Re: Section 16 Planning Application for Proposed Temporary Shop and Services for a Period of 5 Years at Lots 1198 S.B (Part) and 1199 RP (Part) in D.D. 109, Kam Tin, Yuen Long, New Territories (Planning Application No. A/YL-KTN/1048)

We refer to the latest comments from Water Supplies Department, Transport Department, Lands Department, Agriculture, Fisheries and Conservation Department, Planning Department and Drainage Services Department and would like to enclose herewith our Responses-to-Comments Table with revised layout plan to address the abovementioned departmental comments for their consideration.

Title:
 Indicative Layout Plan

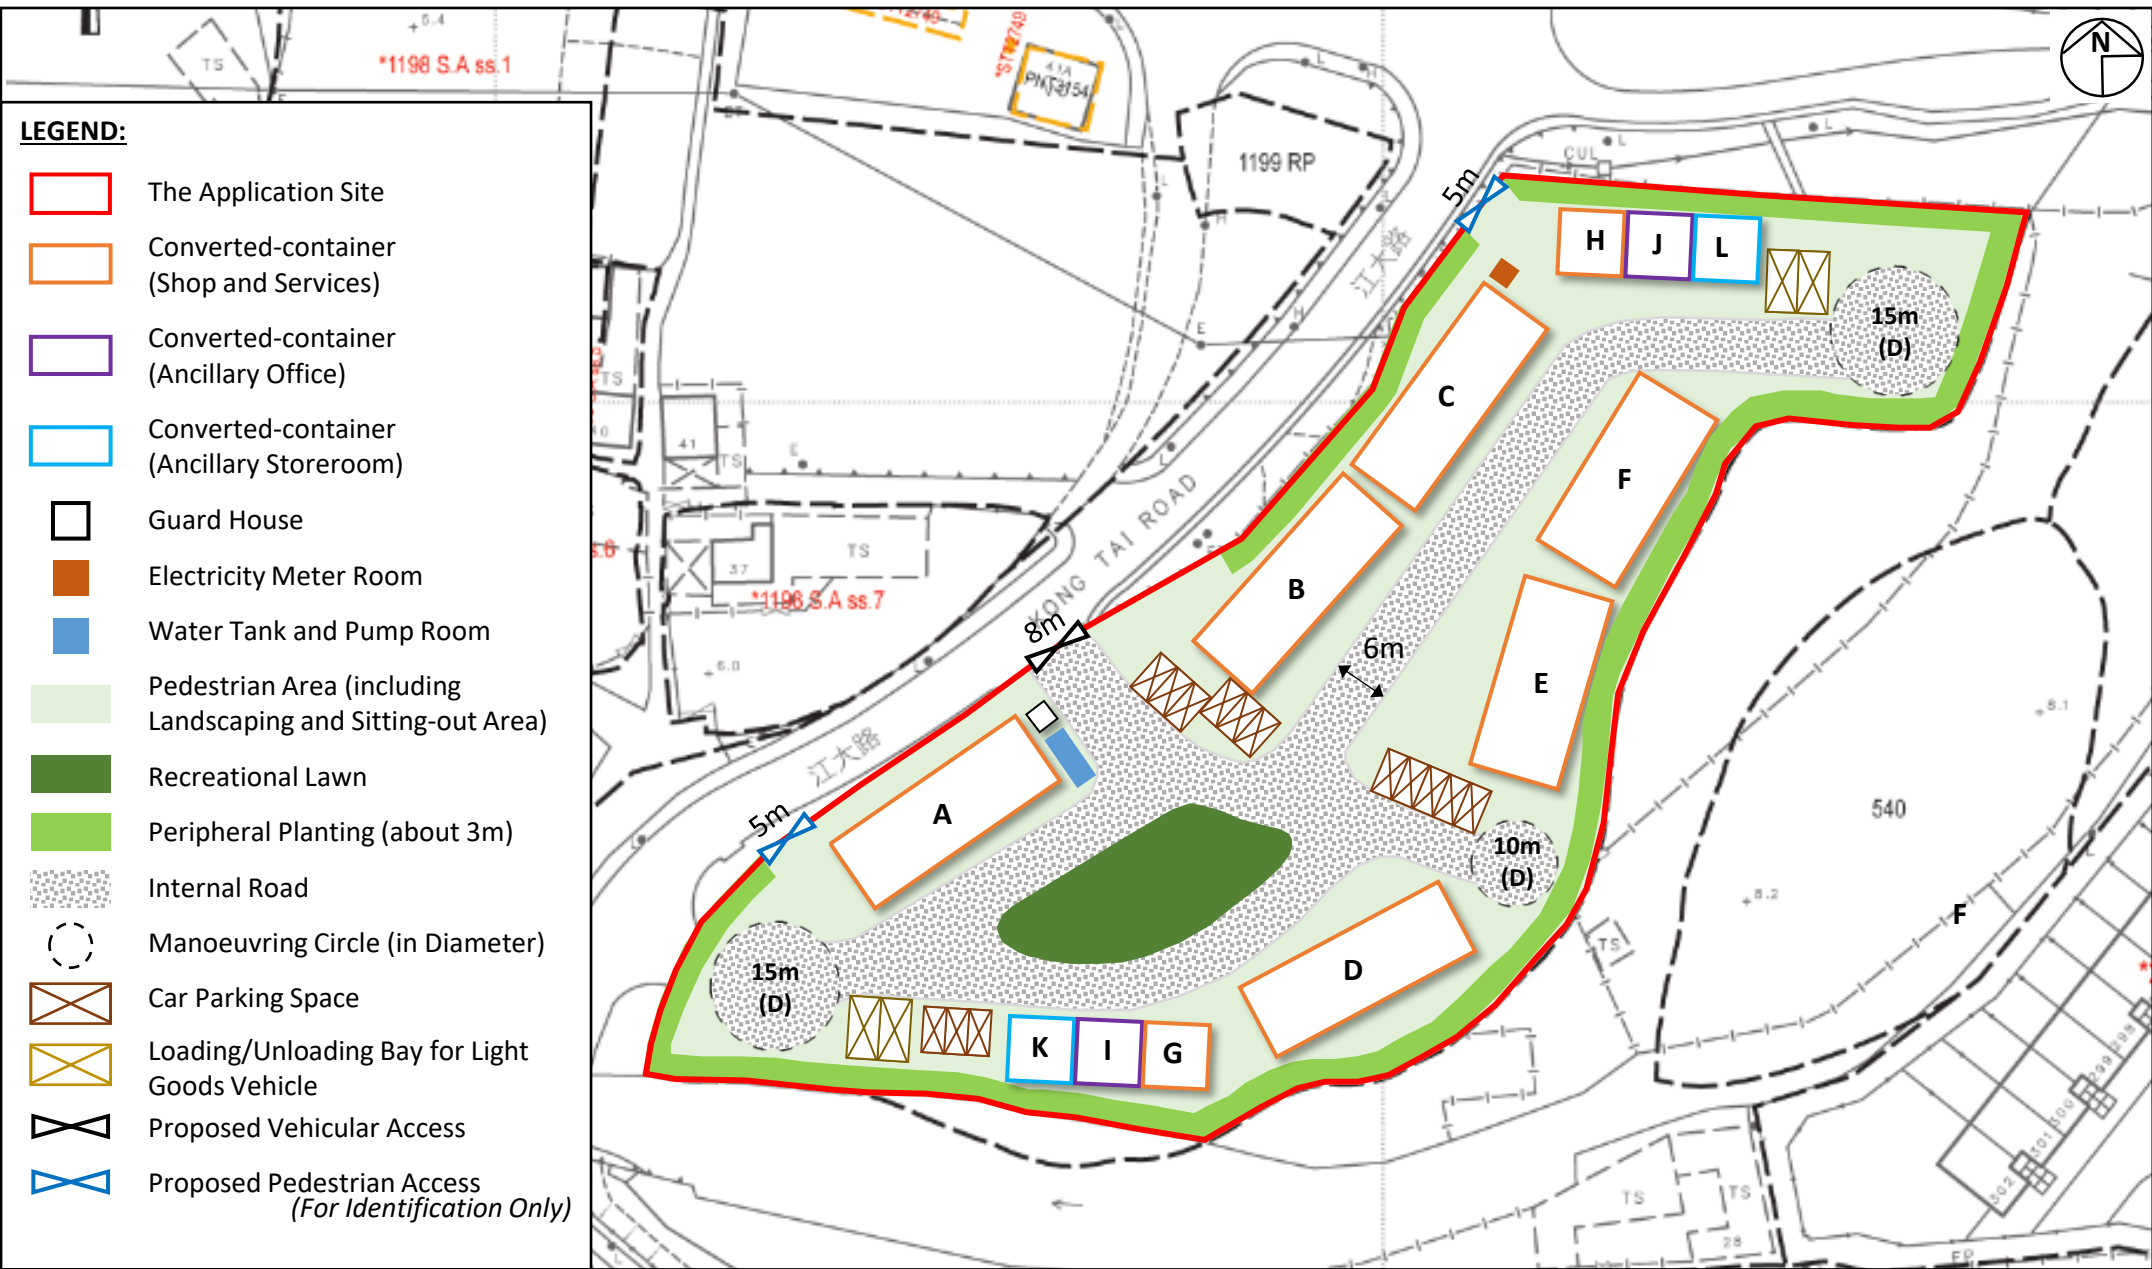
Department	Date	Comments	Responses to Departmental Comments
Planning Department	2.10.2024	<p>With reference to the aerial photo of 2023, some existing trees are observed within the application site. The applicant states in the application form that no tree felling will be involved. However, according to the Indicative Layout Plan (Figure 4) provided, the proposed layout may be in conflict with the existing trees. The applicant is advised to clarify any tree felling is involved in the application.</p>	<p>According to the Applicant and the aerial photo taken in July 2024, the application site is hard paved and contains no existing trees. Therefore, there will be no conflicts with the proposed layout. Please refer to the aerial photo below.</p> 
		<p>The applicant is advised to provide tree information, including location, species, size, general condition with photos, proposed tree treatment and mitigation measures of the trees or landscape proposal for consideration.</p> <p>According to para. 1.1.1, "Species suitable" for the proposed landscape elements (eg. 3m width peripheral planting, landscaping area, etc) will be planted. The applicant is advised to provide the species information.</p>	<p>Since there are no existing trees on the application site, no proposed tree treatment and mitigation measures of the existing trees are necessary for the current application. In order to visual amenity, the Applicant intends to plant suitable species at the periphery of the application site.</p> <p><i>Lagerstroemia Speciosa</i> is proposed as the tree species to be planted with minimum height of 2.75m. The crown spread will be minimum 5m and the stem diameter will be 75mm. The trees will be planted on 1m X 1m X 1.2m deep soil mix or existing good quality soil. Spacing between the stems of two trees is proposed to be about 6m.</p>
